Subject: Virgil C. Summer Nuclear Station (VCSNS) Units 2 and 3 Combined License Application (COLA) - Docket Numbers 52-027 and 52-028 Response to NRC Request for Additional Information (RAI) Letter No. 034

**NRC RAI Letter No. 034 Dated February 12, 2009**

**SRP Section: 2.5.3 – Surface Faulting**

RAI Figure 02.05.03-1.1. 50-Mile Tectonic Features Map

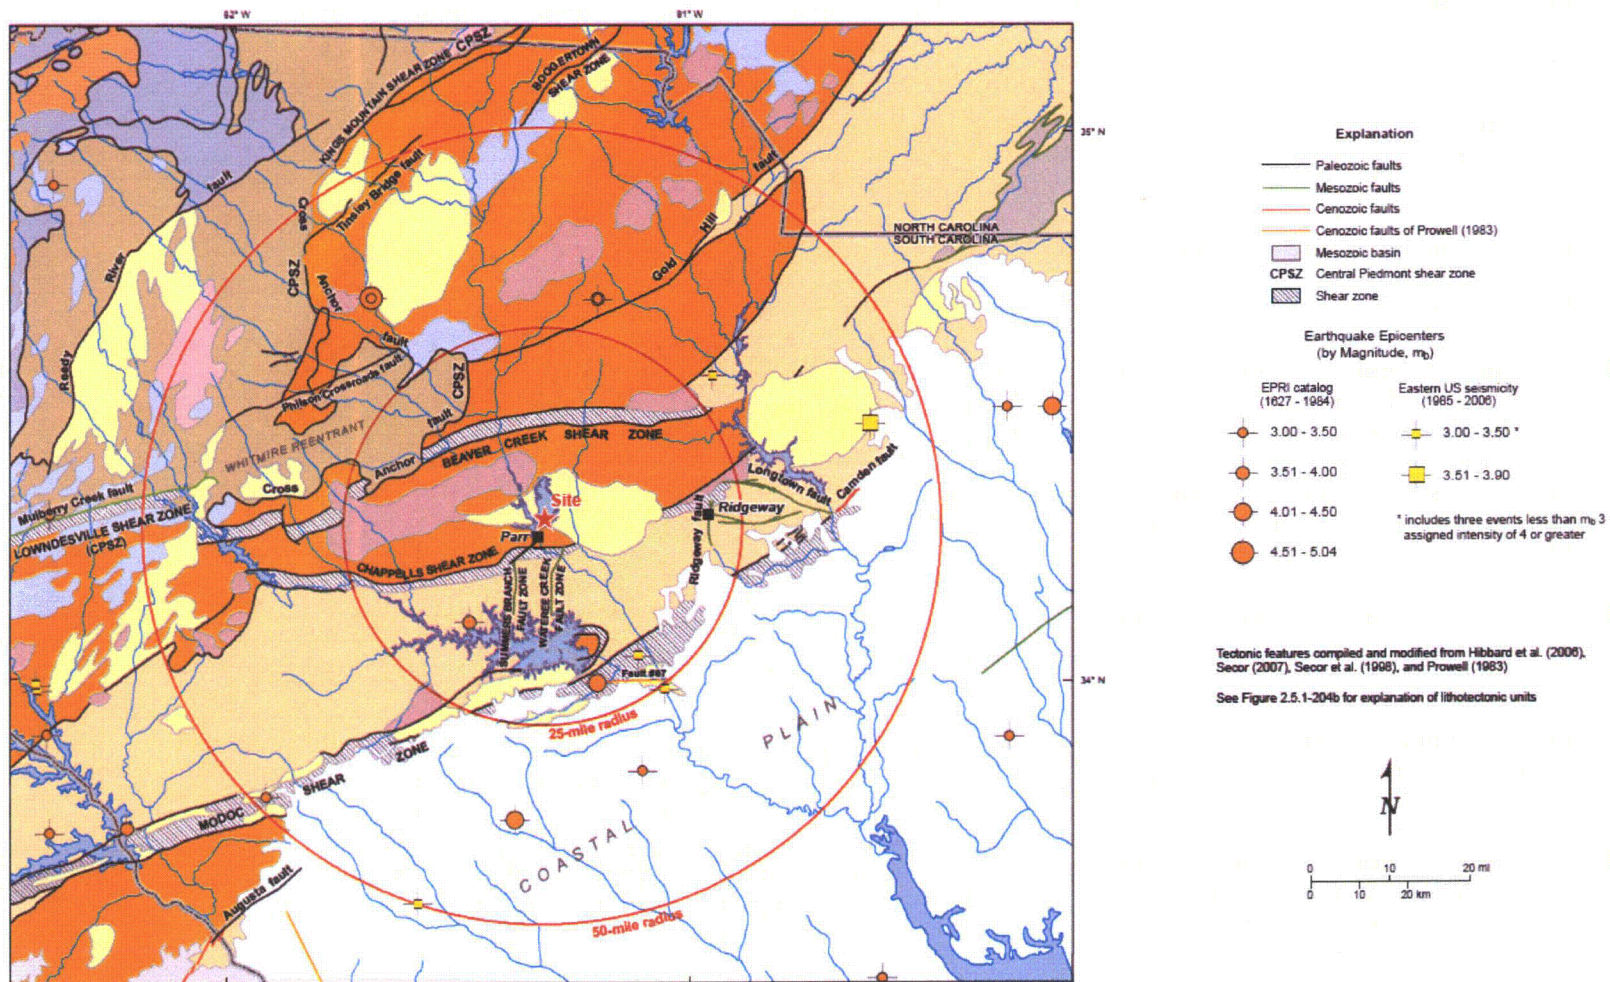
FSAR Section 2.5.3.2 (pgs 2.5.3-5 through 2.5.3-9) discusses 12 bedrock faults which occur within the site vicinity and range in age from Paleozoic to Cenozoic. These faults are summarized in Table 2.5.3- 201 and also discussed in FSAR Section 2.5.1.1.2.4 and Section 2.5.3.4. There is no single figure that shows all 12 faults in the site vicinity relative to lithotectonic units (e.g., the tectonic features map of FSAR Figure 2.5.1-212 labels most, but not all, of these faults and does not include color patterns shown on the map, except that for Mesozoic basins, in the figure legend), and logic for the assigned ages is not summarized in Table 2.5.3-201 or in FSAR Section 2.5.3.4.

In order for the staff to understand the tectonic setting of the site vicinity in relation to these 12 bedrock faults, please accomplish the following:

- (a) Locate all 12 structures on a single lithotectonic map of the site vicinity and include a legend which distinguishes both fault ages and lithotectonic units.
- (b) Summarize the logic presented in FSAR Section 2.5.1.1.2.4 which is used to qualify ages of these 12 faults, possibly in a modified Table 2.5.3-201.
- (c) Include in Section 2.5.3 the information provided in response to RAIs for Section 2.5.1 which is related to these 12 faults, as appropriate.

- (a) RAI Figure 02.05.03-1.1 shows the 12 faults within the site vicinity. FSAR Figure 2.5.1-204b provides a detailed explanation for RAI Figure 02.05.03-1.1.
- (b) Revised FSAR Table 2.5.3-201 provides information used to assign ages to the 12 faults within the site vicinity.
- (c) FSAR Subsection 2.5.3.4 text will be revised as described in response to RAI 02.05.03-4. Also, as noted in item (b) above, the revised FSAR Table 2.5.3-201 provides information used to assign ages to the 12 faults within the site vicinity.
